LAND USE APPLICATION SUMMARY

Property Location: 1221 Nicollet Mall, 1226 Marquette Avenue, 1200 Marquette Avenue
Project Name: Westminster Presbyterian Church Project
Prepared By: Aaron Hanauer, Senior City Planner, (612) 673-2494
Applicant: Rob Hunter, James Dayton Design
Project Contact: Rob Hunter, James Dayton Design
Request: Church building addition and outdoor plaza space
Required Applications:

Variance	Variance to reduce the minimum floor area ratio from 2.0 to 1.2.
Variance	Variance to increase the maximum off-street parking from 144 spaces to 264 spaces.
Variance	Variance to reduce the drive aisle width from 18 feet to 15'-6".
Variance	Variance to increase the number of freestanding signs allowed from one to three.
Site Plan Review	For a 49,244 square foot building addition and new outdoor plaza space

Figure 4 – Passenger Vehicle Turning Analysis

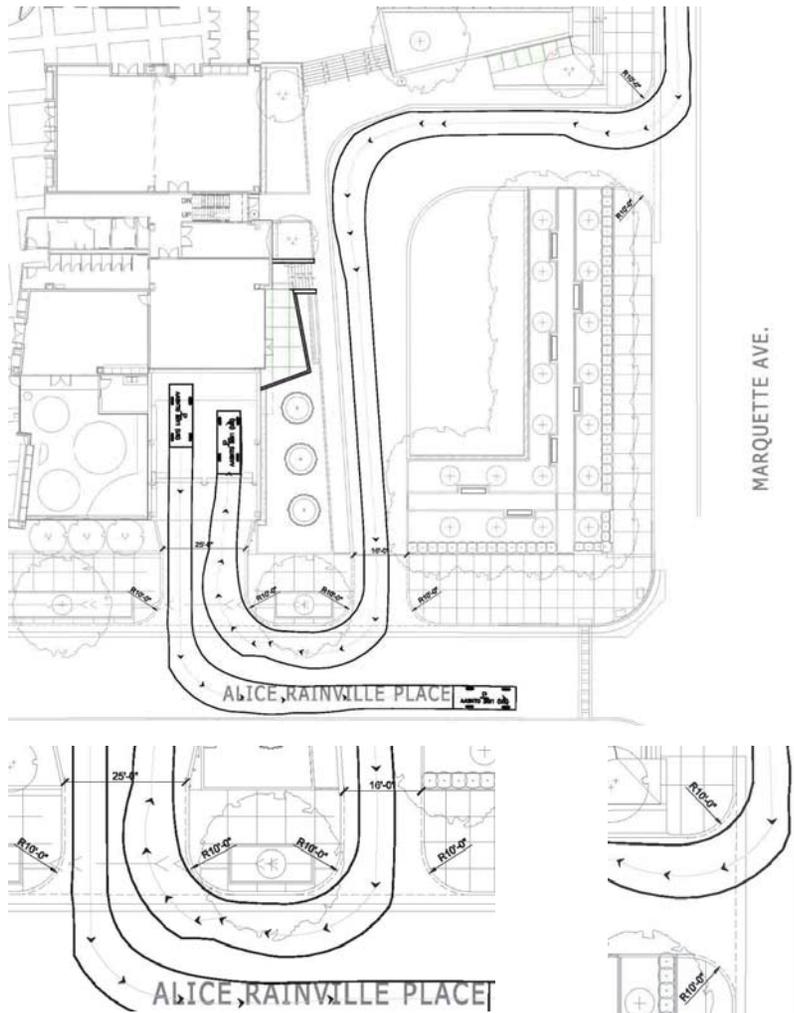
- Proposed driveway aprons are shown incorrectly and must be constructed to City standards with level sidewalks and 5' radii, not 10'radii. All driveway aprons shall be designed and constructed to City standards. All driveway aprons shall be shown graphically correct on all related plan sheets. The Minneapolis Standard Plate ROAD-2003 provided on Sheet C8.0 has been updated and shall be replaced with ROAD-2003-R1. Please refer to the following: http://www.minneapolismn.gov/publicworks/plates/public-works_road.
- Note to the Applicant: Please continue to coordinate with Rick Kreuser at (612) 673-3624, the project manager overseeing the reconstruction of Nicollet Mall.

SITE PLAN
C4.0

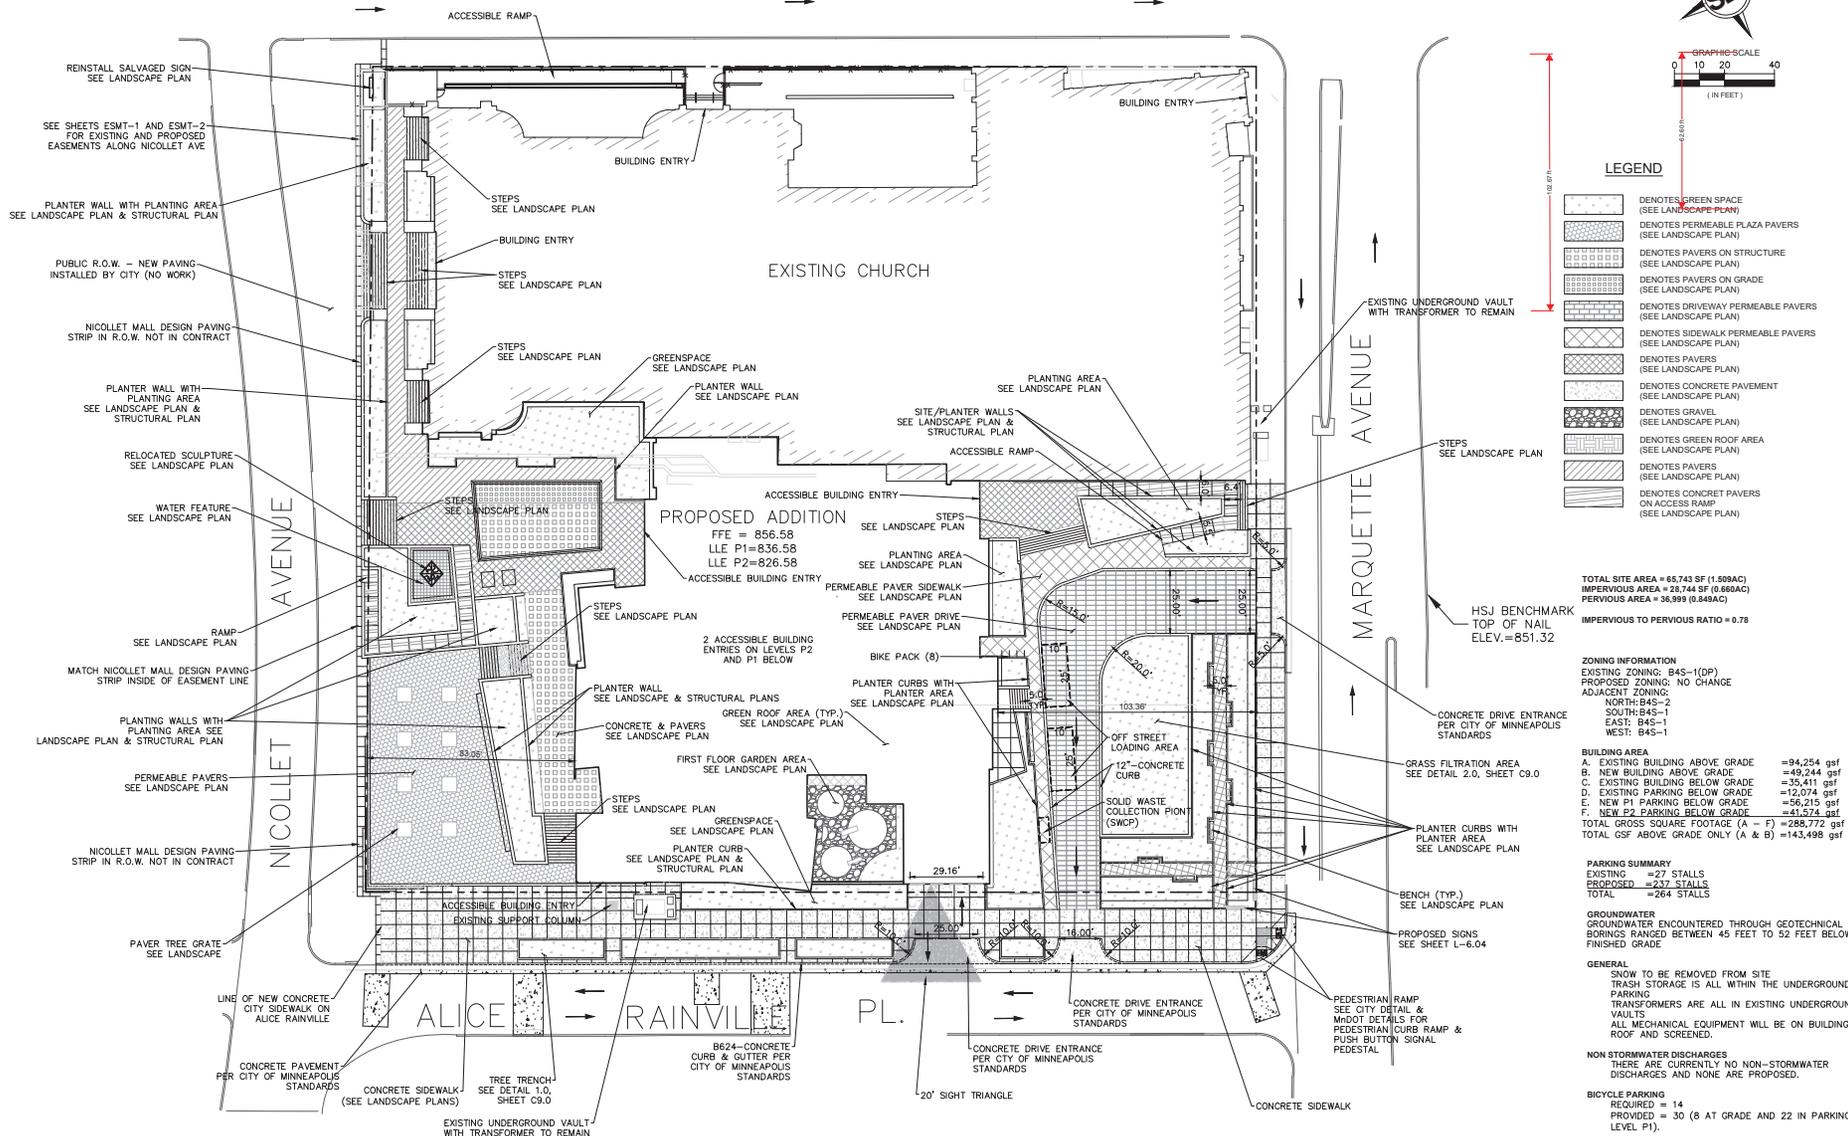
- Please clarify if the Total Site, Impervious and Pervious Areas identified on Sheet C4.0 are the total site areas or disturbed areas. The total site appears to be larger than this. The areas based on disturbed area should still be provided, but clarified.
